STAFF RECOMMENDATION 2007 Eastland Avenue October 21, 2020

Application: New Construction—Addition; Show Cause
District: Eastwood Neighborhood Conservation Zoning Overlay
Council District: 06
Base Zoning: R6
Map and Parcel Number: 08306029800
Applicant: Molly Bradstreet
Project Lead: Paul Hoffman; paul.hoffman@nashville.gov

Figures 1 and 2: Front of 2007 Eastland Avenue and lap sided chimney on the addition.

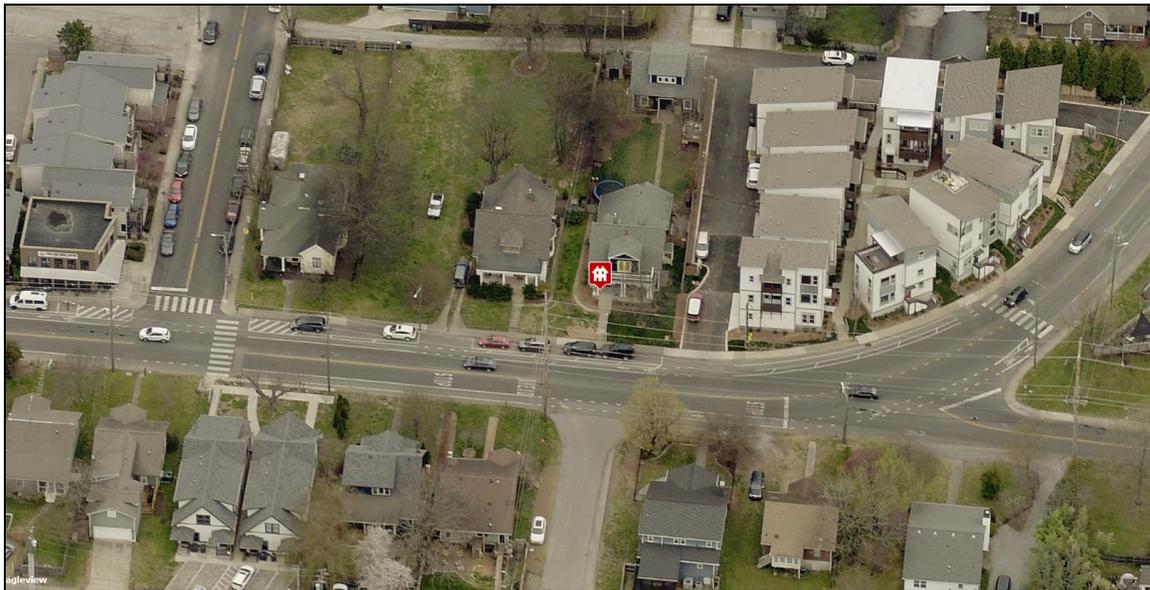
Background: MHZC staff approved the rear addition to 2007 Eastland Avenue in May 2020 and issued Preservation Permit 2020-031856. On a progress inspection, on 9/18/2020 staff observed that the chimney had been clad in lap siding instead of brick. (See Figure 2.) Staff notified the owners who replied on 9/22/2020 that they chose to request the permit revision rather than correct.

Staff finds that the lap siding as installed does not meet Section II.B.1.d for Materials, or II.B.2 for Additions.

Staff finds that the chimney cladding as installed does not meet Section II.B.1.d for Materials or II.B.2 for Additions of the Eastwood Neighborhood Conservation Zoning Overlay Design Guidelines. Staff recommends the chimney be corrected to meet the permit within sixty (60) days from the Commission's decision.

Figure 3. The drawings approved for Preservation Permit 2020-031856 indicated the chimney being clad in brick.

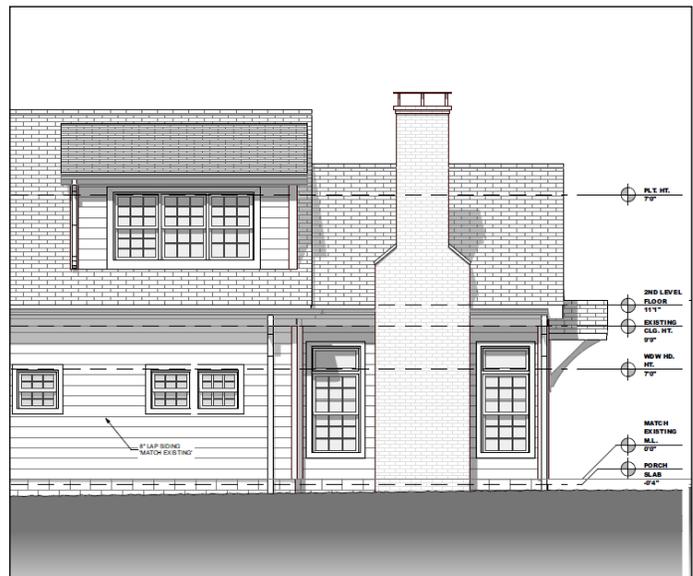
Historically, chimneys were brick, stone or stucco. Wood lap siding would not have been a safe material to use for a chimney, historically. Since historic materials are still readily available today, they are what the Commission has always required. Other such violations have been required to be corrected. Staff could not find any conditions that were unique to this house or property that would warrant a revision to the permit.
